R. T. HICKS CONSULTANTS, LTD.

Thank you for your review of Wool Head 20 St Com #703 (#NRM2003454039).

Proposed Sample Sites for Closure

Advance Energy Partners Hat Mesa LLC
Wool Head 20 State Com #703

Plate 11

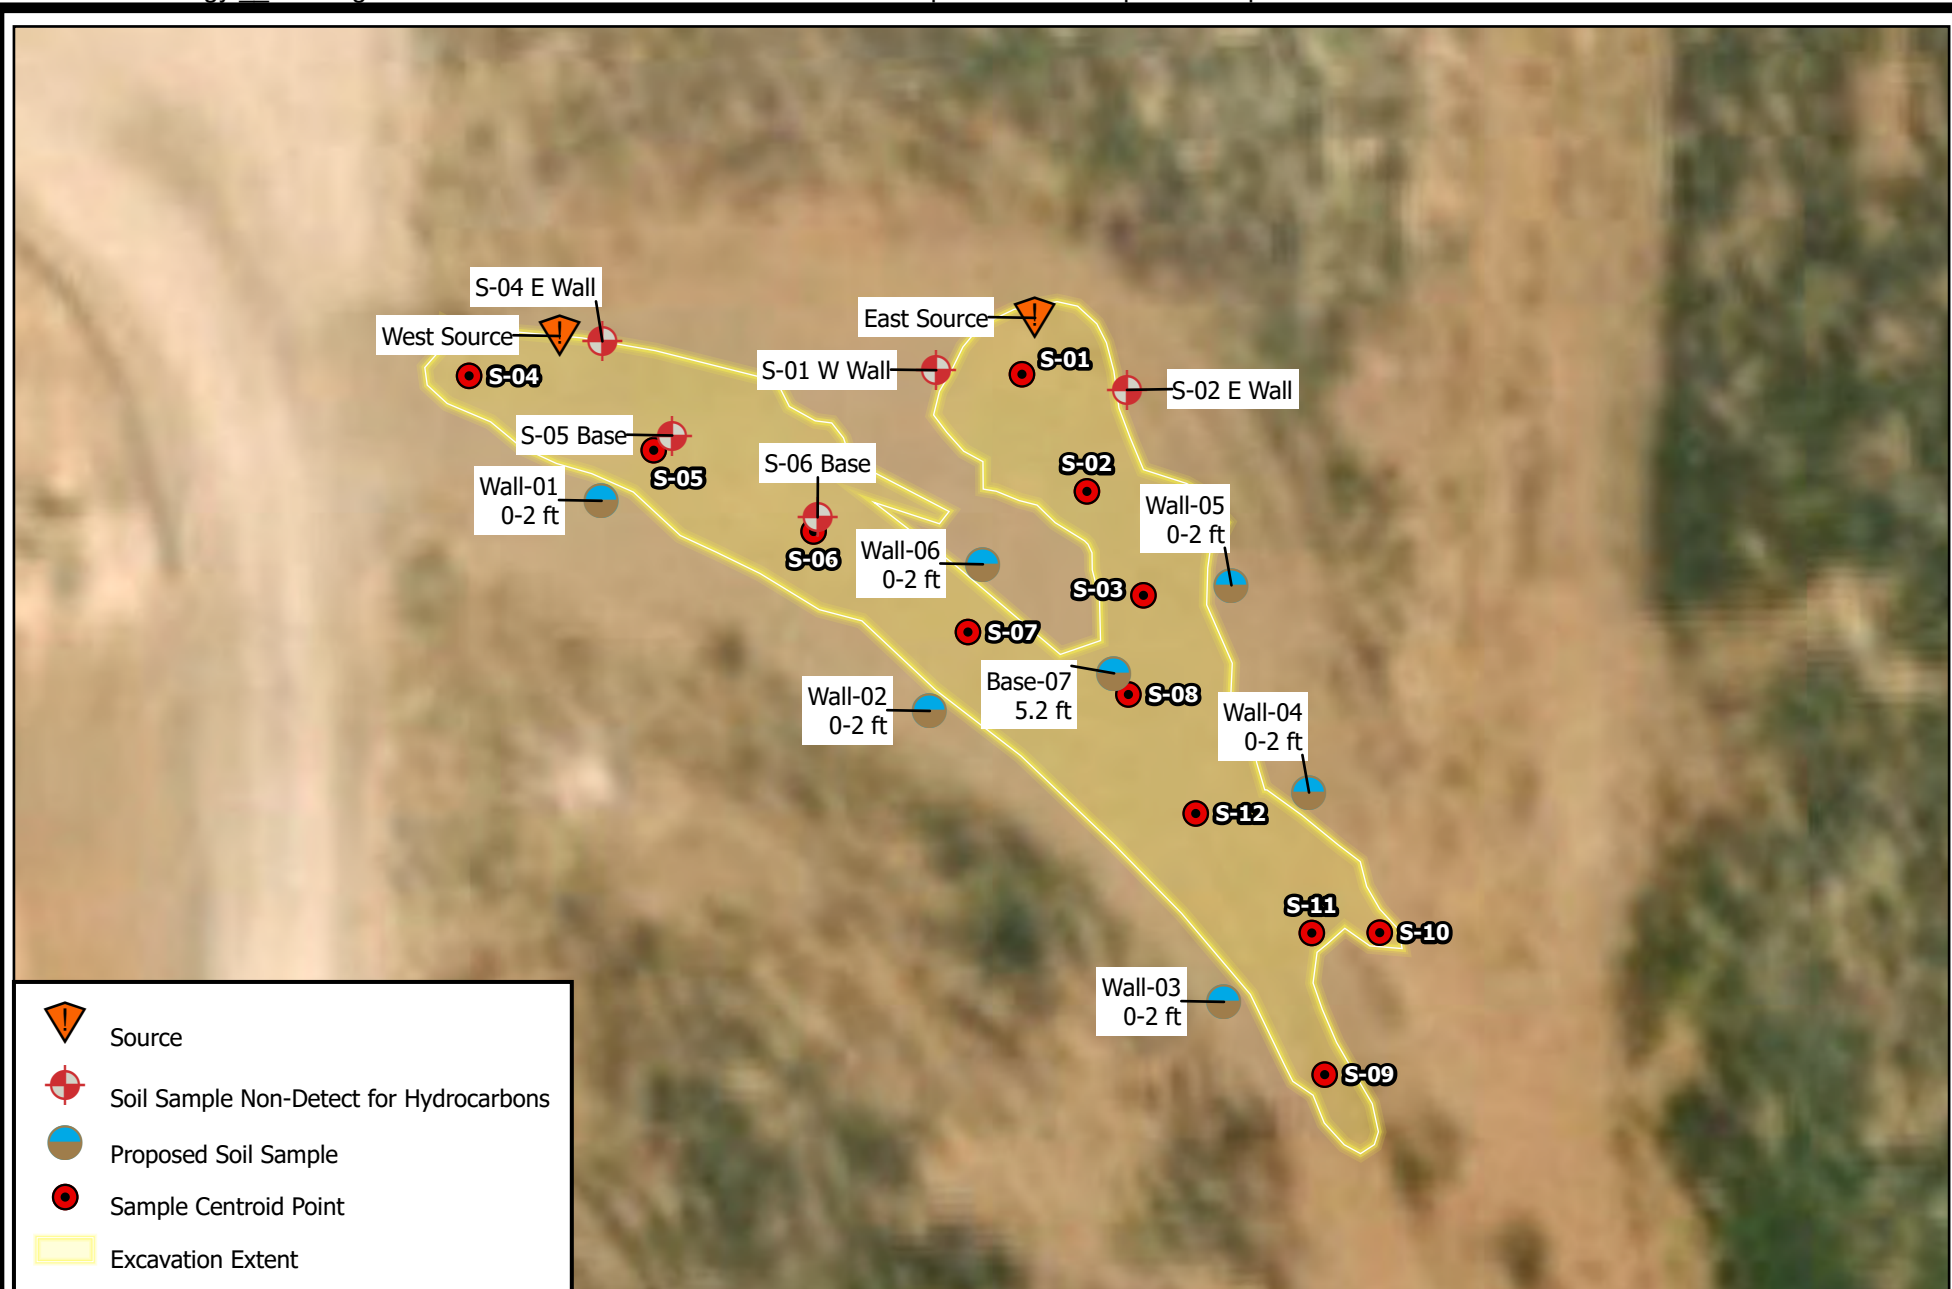
Since the excavated material is no longer present, we propose testing native soil along the periphery of the release extent for hydrocarbons (0-2 ft with hand auger), as well as an additional base sample (5.2 ft with hand auger) at the confluence of the two release sources where the base chloride concentration was the highest.

Attached to this email is a map (Plate 11) showing prior soil sample locations (including those testing non-detect for hydrocarbons) and the proposed "wall" testing to demonstrate the vertical delineation of any hydrocarbon soil impact. I have also attached a copy of our sampling data for your convenience in review of this plan.

- S-08 Base at native soil – hand auger to 5.2 ft (highest base chloride – at confluence of 2 source flow paths)
- Vertical delineation of native soil 0-2 ft with hand auger
 - E wall of S-03
 - SW wall of S-05
 - SW wall of S-07
 - SW wall of S-02
 - SW wall of S-12
 - NE wall of S-11
